UNITED STATES DEPARTMENT OF COMMERCE United States Patent and Trademark Office Address: COMMISSIONER FOR PATENTS P.O. Box 1450 Alexandria, Virginia 22313-1450 www.uspto.gov

APPLICATION NO.	FILING DATE	FIRST NAMED INVENTOR	ATTORNEY DOCKET NO.	CONFIRMATION NO.
10/577,575	09/05/2006	Steven Andrew Skelton	KRB-0229US	7478
22204 7590 06/11/2009 NIXON PEABODY, LLP				INER
401 9TH STRE SUITE 900	· · · · · · · · · · · · · · · · · · ·	KIRSCH, ANDREW THOMAS		
	N, DC 20004-2128		ART UNIT	PAPER NUMBER
			3781	
			MAIL DATE	DELIVERY MODE
			06/11/2009	PAPER

#### **DETAILED ACTION**

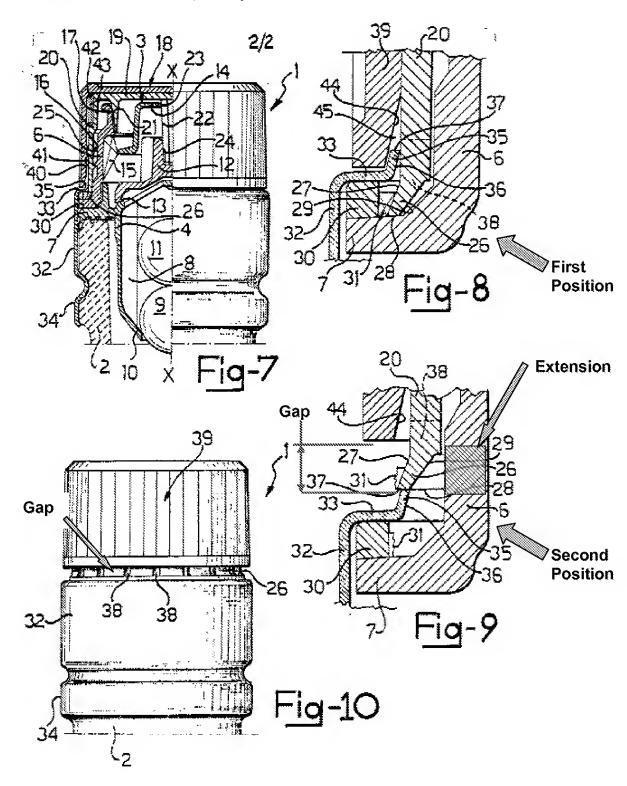
- 5. Claims 1-10 are rejected under 35 U.S.C. 102(b) as being anticipated by UK Patent Application GB 2158424 (Guala hereinafter).
- 6. In re claim 1, with reference to Figs. 7-10 below, Guala discloses: A tamper-evident closure (1) for a container, the closure comprising: a first portion (6, 18, 20, 39) including an inner (6) and outer part (18, 20, 39); and a second portion (30), the outer part (18, 20, 39) being movable relative to the inner part (6) (see Figs. 8 and 9) from a first position in which the outer part is immediately adjacent the second portion (30, see Fig. 8) to a second position in which there is an unobstructed gap (see Fig. 9) there between, the inner and outer parts being constructed and arranged to become irreversibly locked in the second position so that the outer part cannot be moved back to

the first position to close the gap. Note that the gap is considered to be unobstructed in

the areas between each of the plurality of ratchets 38.

- 10. In re claim 5, with reference to the Figs. above, Guala discloses the claimed invention including wherein the first portion (6, 18, 20, 39) includes a ratchet arrangement (26) for locking the inner (6) and outer parts (18, 20, 39) in the second position (see Fig. 9).

- 12. In re claim 7, with reference to the Figs. above, Guala discloses the claimed invention including wherein the gap is formed at the respective adjacent peripheries of the portions (see Fig. 10).

- 13. In re claim 8, with reference to the Figs. above, Guala discloses the claimed invention including wherein the inner part includes an extension (see Fig. 9) which

17. On page 9, of the Remarks, Applicant argues that the gap as described in Guala and interpreted in the previous rejection is obstructed by the ratcheting means 26. However, when viewing Fig. 10, there exists a significant gap created between the lines added by the examiner for clarity on Fig. 9. The claim language of "an unobstructed gap" does not preclude the gap shown in Fig. 9 (being located immediately behind ratchet 26 in to the page correlating to the part labeled "gap" on Fig. 10.). When interpreted thusly, there exists an empty, unobstructed gap (there being many gaps between each two adjacent ratchet means 26 around the circumference of the closure) between the first portion outer part and the second portion.
